Geotechnical Inspection and Technical Review of Santa Margarita River Marine Corps Air Station Levee, U.S. Marine Corps, Camp Pendleton, CA, 19-20 November 2019

Final report

Under Project DD1144-2019-GSL-604, Independent Technical Review of the Santa
Margarita Levee Rehabilitation Project, MIPR M0220821MPFE001

Figure 3. East segment inspection photos in vicinity of North Lat 33.3105, West Long 117.3439: (A) landside slope with slight weathering, (B) typical transverse crack in levee crest, (C) levee crest with Basilone Road Bridge in background, and (D) observed depressions on riverside toe.

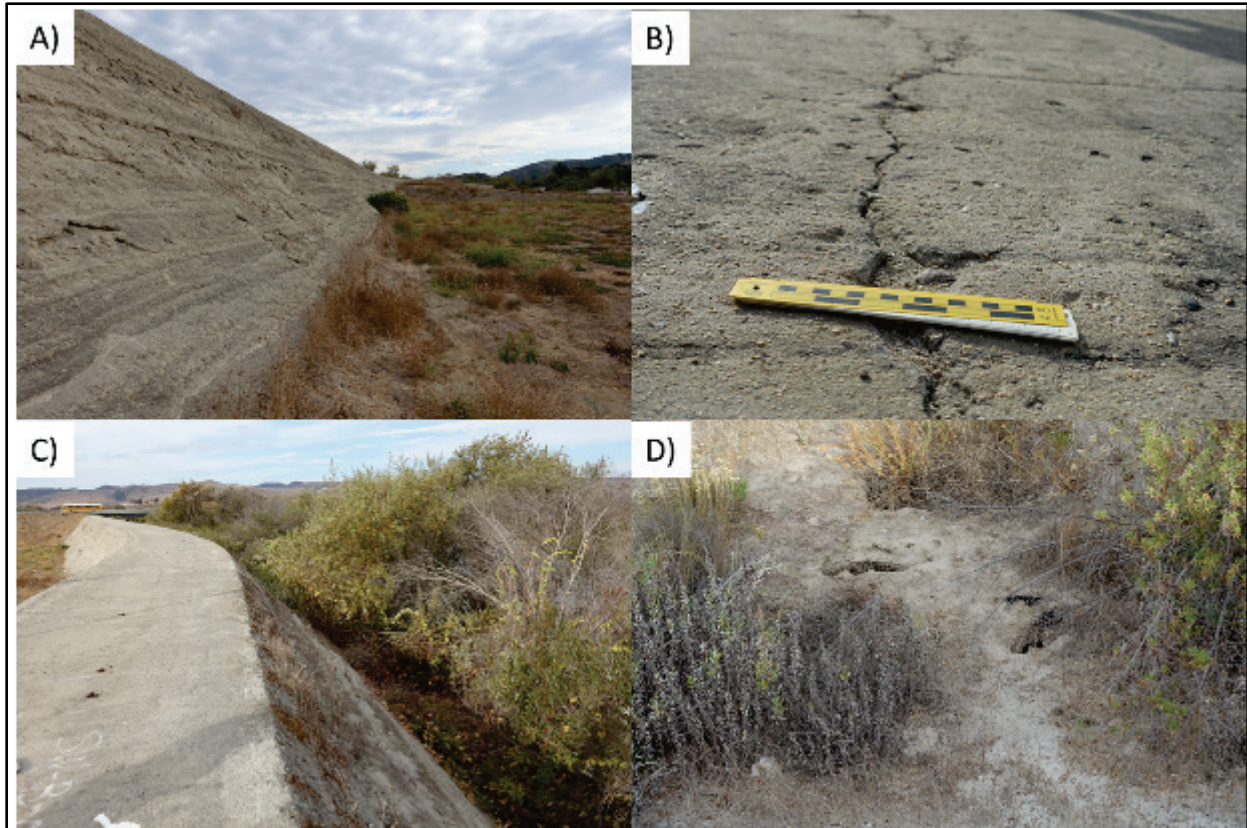
Figure 4 shows photos of the levee between the bridge and the Ranch House road (observation point at North Lat 33.3105, West Long 117.3439). Figure 4A shows the landside slope of the soil-cement levee with slight weathering. Figure 4B shows typical transverse cracking in the levee crest. Figure 4C shows the soil-cement embankment crest in very good condition. Figure 4D shows depressions at the riverside toe in the riprap revetment. The depressions varied in size with the largest being approximately 8 in. (20.3 cm) wide and 1 ft (30.5 cm) long with a depth of 8-12 in. (20-31 cm). The depressions at most locations contained riprap, but most of the soil cover was eroded away. These types of depressions were evident along the entire levee system with the density of observations being greatest along the airfield segment. In some locations, observations could not be made due to the presence of heavy vegetation.

1. Vegetation is adversely impacting the levee. Instances where woody vegetation is growing out of the embankment (near the Ranch House reach) are likely causing deformation and sliding of the landside slope. The presence of woody vegetation at the riverside toe of the levee is likely causing deformation of the riprap revetment. This condition could cause preferential seepage paths that would provide concentrated seepage pathways beneath the embankment. Additionally, the presence of both woody and weedy vegetation inhibits observations during flooding and may prevent observation of levee distress that could lead to failure of the levee that otherwise might have been prevented through flood-fight methods. Levee inspections during flood conditions are critical and important to ensure levee safety.

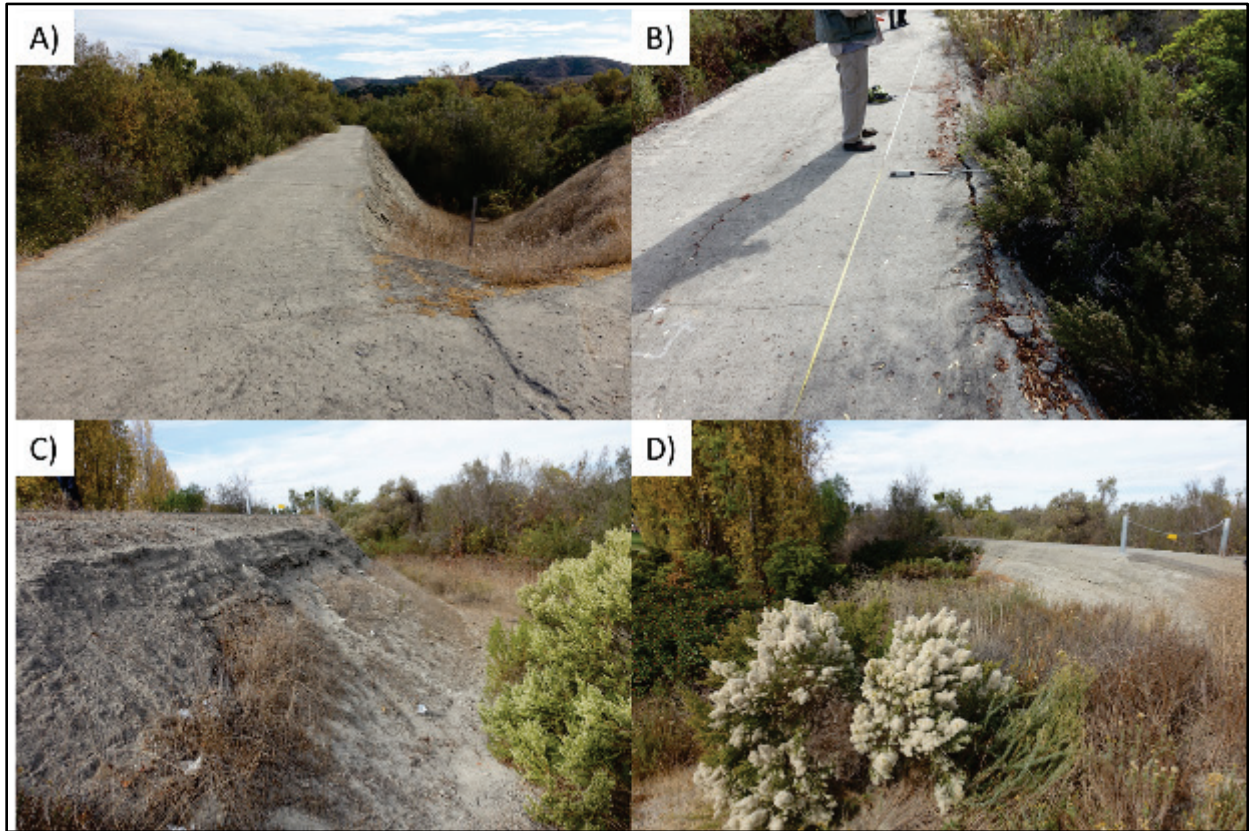
Figure 5A shows vegetation conditions where the levee guide vane meets the levee road embankment, with the presence of heavy vegetation at both toes of the levee. Figure 5B shows a longitudinal crack 46 ft (14 m) in length near the landside shoulder of the levee crest, a short distance from the road and guide vane intersection. The likely cause of the cracking is vegetation growing out of the embankment slope. Additionally, an old irrigation system was observed at the levee toe, which was used to water planted vegetation on Ranch House grounds. The system did not appear operational at the time of inspection, but watering close to the levee prism in the past may have contributed to the existing conditions. Figure 5C shows an example of more severe embankment weathering on the riverside levee slope along the Ranch House road leading to the guide vane intersection. Finally, Figure 5D shows vegetation in the vegetation-free zone at the termination of the levee at Vandegrift Boulevard. Figure 6 shows another example of severe weathering to the levee slope.

2. Weathering of the embankment side slopes needs remediation before further loss of embankment material occurs. If left unchecked for the long term, this condition could lead to a need to replace the levee embankment entirely. Likely remediation would involve regrading the slope with the addition of soil-cement materials and/or armoring the slope with filter cloth and riprap or articulated concrete mats.

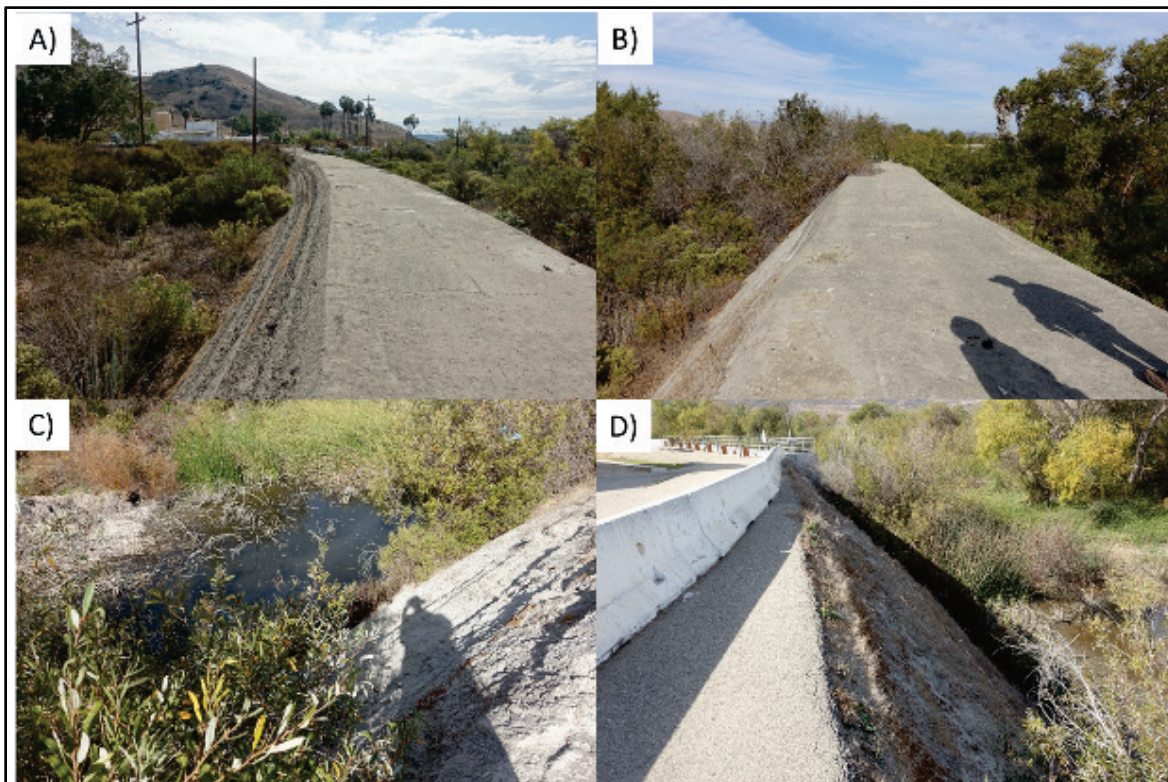
However, landside vegetation was not as dense as that observed on the riverside toe of the levee (Figures 7A and 7B). Moderate weathering of the soil-cement embankment was observed at some of the lift contacts on the riverside of the levee (Figure 7C). Near the pump station, standing water was observed at the riverside toe of the levee both upstream and downstream of the pump station (Figures 7C and 7D). Transverse cracking was identified in multiple locations, extending from the riverside toe across the levee to the landside toe. Close examination of Figure 7A shows an example of the transverse cracking that is present. The cracking was tight and did not appear to be recently formed. The presence of woody vegetation and standing water on the riverside toe restricted access and inspection of the riverside riprap revetment.

1. Vegetation is adversely impacting the levee. The presence of woody vegetation at either toe of the levee is likely causing deformation of the riprap revetment that could cause preferential seepage paths beneath the embankment. Additionally, the presence of both woody and weedy vegetation inhibits observations during flooding and may prevent observation of levee distress that can lead to failure of the levee that otherwise may have been prevented by observation and flood fighting (e.g., sand-bagging boils).

2. Standing water on the riverside levee toe should be investigated. It is likely that the culprit is a blocked drainage ditch. Either the blockage is due to vegetation, or the ditch is silted in. Comments made by public works staff during the ERDC inspection indicated that standing water is a recent development. This condition should be investigated to ensure that good drainage is maintained to facilitate inspection during dry periods. Maintenance to restore drainage function is important as, left unchecked, this condition will create future environmental issues and establish an unwanted precedence where none previously existed.

Figure 7. Floodwall segment inspection photos: -(A) landside of floodwall looking west, (B) floodwall tie-in to the airfield levee, (C) animal burrows or depressions at the levee tie-in with the airfield segment, and (D) landside of floodwall looking west from floodwall station 500+723.

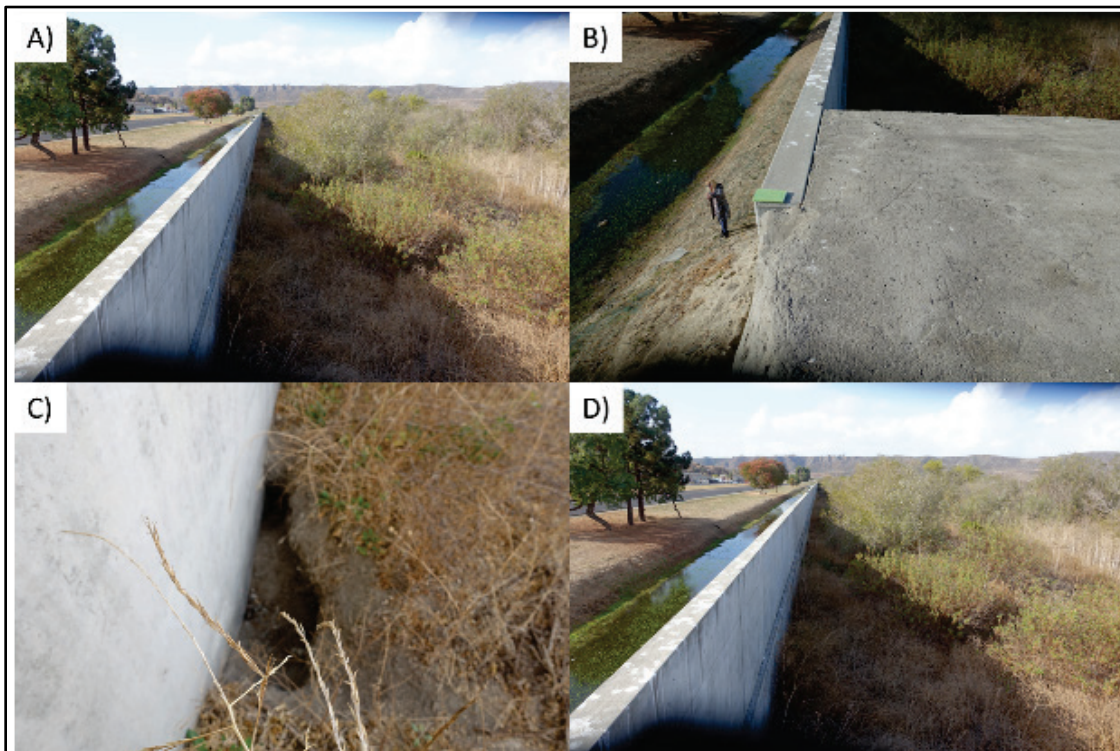
Figures 8A to 8D show the riverside and landside of the floodwall as well as the landside drainage ditch. Numerous small rodent burrows were observed within 5 to 10 ft (1.5 to 3 m) landside of the floodwall. Figure 8A shows the vegetation at the downstream levee-floodwall tie-in. Figures 8B and 8C are views looking east, while Figure 8D shows the floodwall looking west. Vegetation is growing against the riverside of the floodwall in all these views.

1. Both weedy and woody vegetation on the riverside of the levee is inhibiting observation of the riprap revetment. This vegetation makes riverside inspection of the floodwall difficult.
2. Numerous depressions were observed on the riverside of the floodwall. These depressions are similar to those observed in the east segment.

Figure 8. Floodwall segment inspection photos: (A) levee embankment with riverside vegetation at floodwall-levee tie-in, (B) alignment of the floodwall looking east, (C) land-side of floodwall looking east, and (D) center of floodwall.

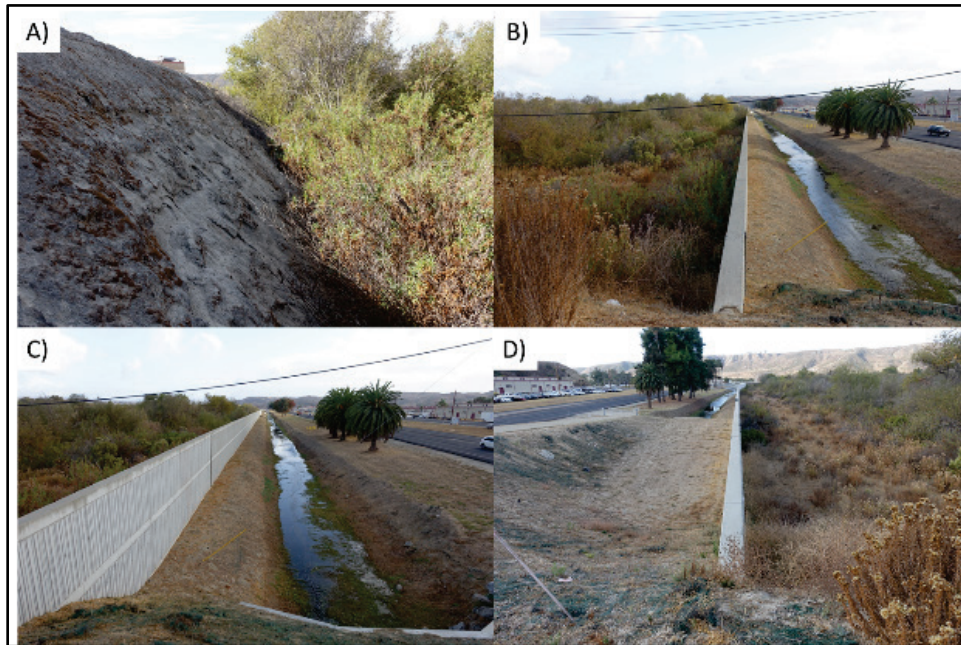
Figures 9A through 9D show different views of the floodwall near its intersection with the airfield segment. Figure 9A is a view looking west and

shows woody and weedy vegetation on the riverside of the floodwall. Also noteworthy at this location were large depressions in the riverside riprap revetment along the base of the floodwall. Depressions were mainly observed on the riverside of the floodwall and within a few feet of the wall. Figure 9C shows an example of the type of depressions that were observed. The largest observed depression was approximately 3.5 ft (1 m) long and 1 ft (0.3 m) wide, with a depth greater than 1 ft (0.3 m). Complete inspection of the riverside floodwall was inhibited by the presence of heavy vegetation. Figure 10B shows the overlap between the floodwall and the levee at levee station 100+729.

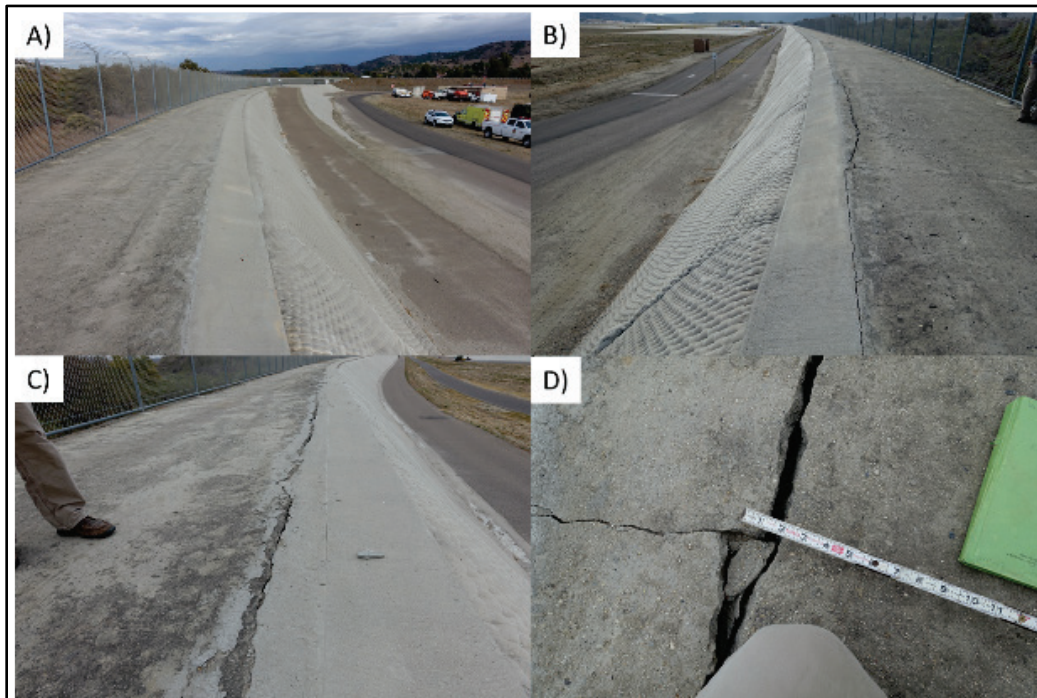
The airfield levee segment extended from station 100+729 to station 103+775. The levee embankment in this segment was constructed of composite soil-cement and a geogrid reinforced earth fill (Figures 10A to 10D). The reinforced earth fill was located on the landside slope; due to weathering and poor performance, it had to be remediated. Remediation of the landside slope consisted of installed fabric-formed concrete on the slope. Cracking at the interface of the fabric-formed concrete and the soil-cement portion of the crest was observed along the extent of this segment (Figures 10B to 10D).

Crack monitoring gauges were observed at several locations, and project personnel indicated that they were monitoring the crack dimensions: current conditions were reported to be stable.

1. Vegetation is adversely impacting the levee right-of-way. The presence of woody vegetation on the riverside toe of the levee is likely causing deformation of the riprap revetment and could provide preferential seepage paths beneath the embankment. Additionally, the presence of both woody and weedy vegetation inhibits observations during flooding and may prevent observation of levee distress that can lead to failure of the levee that otherwise may have been prevented.
2. Crack monitoring should be continued at the interface of the fabric-formed concrete and the levee crest material.
3. Depressions in the riprap revetment should be inspected following vegetation removal, and a remediation plan should be initiated.

Figure 10. View of riverside airfield segment: (A) slight weathering of riverside slope, (B) erosion of surface material at riverside revetment, (C) depression in riverside riprap revetment, and (D) riverside slope and vegetation-free zone at riverside toe looking east.

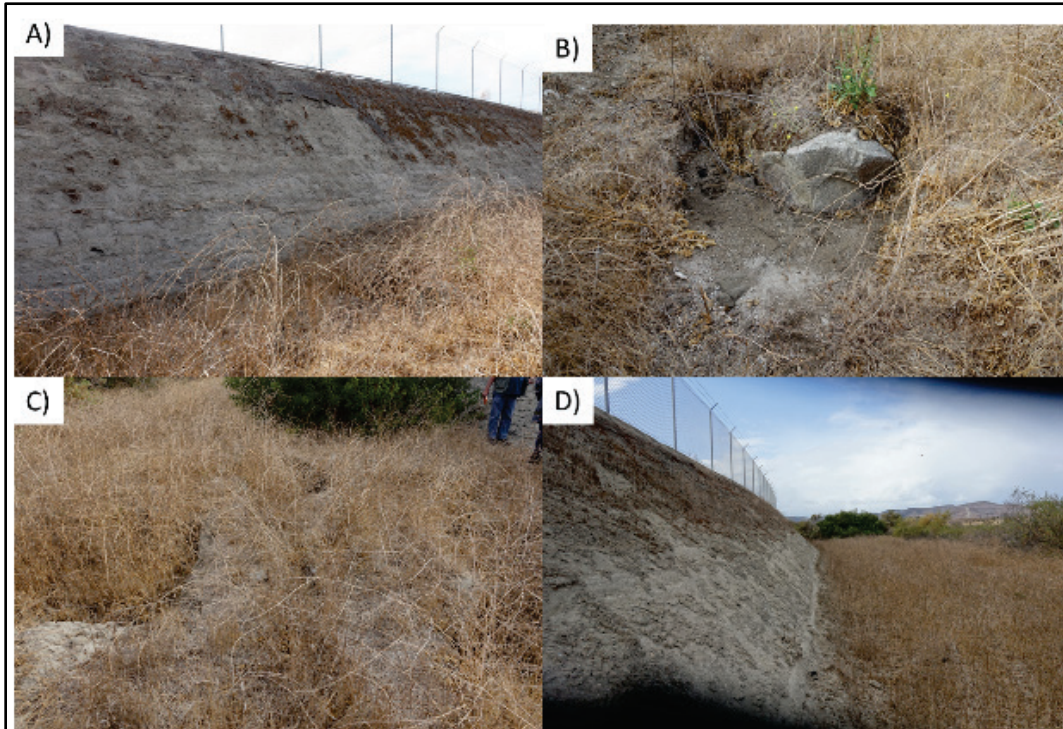
Moderate weathering of the riverside embankment slopes was observed, along with numerous depressions of the revetment where rock was absent and/or assumed to have significantly settled (see Figures 11A through 11D). Woody vegetation was observed growing in the vegetation-free zone at the riverside toe along much of this segment and from the riverside riprap revetment. Figures 11A and 11D are areas where woody vegetation is absent and permits better close inspection of riverside conditions, providing mowing of grass-covered areas is periodically performed.

Figure 11. Areas identified for launchable riprap (yellow double line) in BergerABAM (2019a).

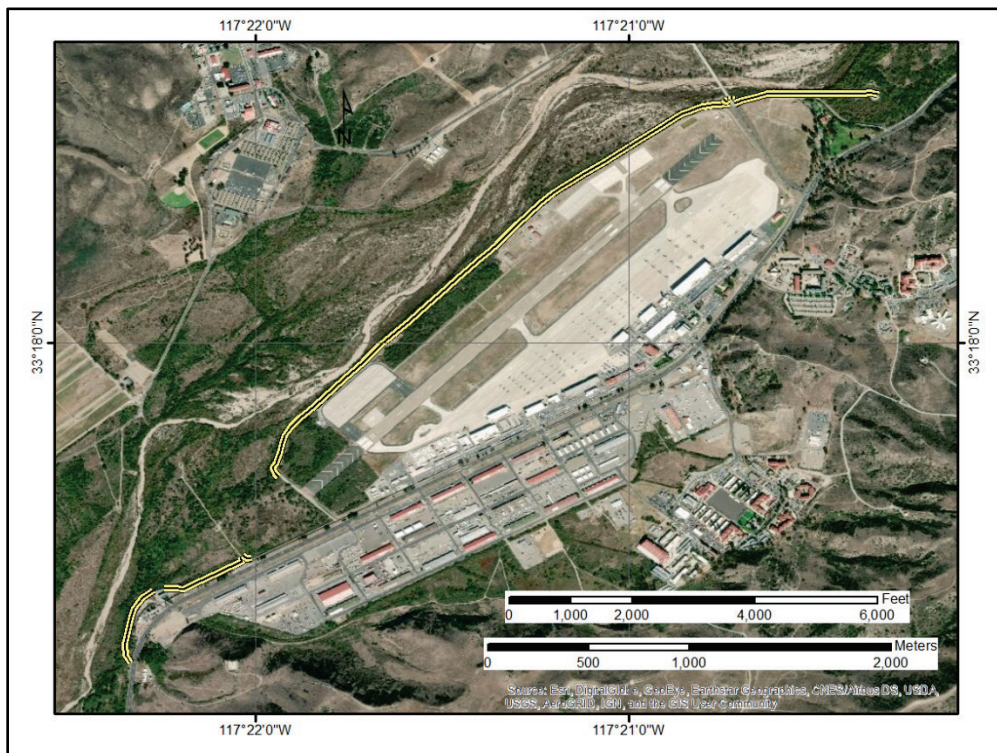
Installation of the launchable riprap will address issues associated with scour and the observed depressions in the current riprap revetment. Locations identified where launchable riprap are to be installed are shown in Figure 12. Figures 13 and 14 show the design of the launchable riprap as well as the access path for the levee and floodwall sections (BergerABAM 2019a). The proposed design will remediate the existing riprap with the launchable riprap design.

As scour occurs, the riprap is designed such that gravity will force the riprap at higher elevations to flow into the potential scour hole, arresting further progression. This remediation addresses two deficiencies: it will protect the riverside slope from direct contact by weathering and erosion, which is slowly degrading the embankment, and it will also provide a dynamic response to possible scour induced by high flow events.
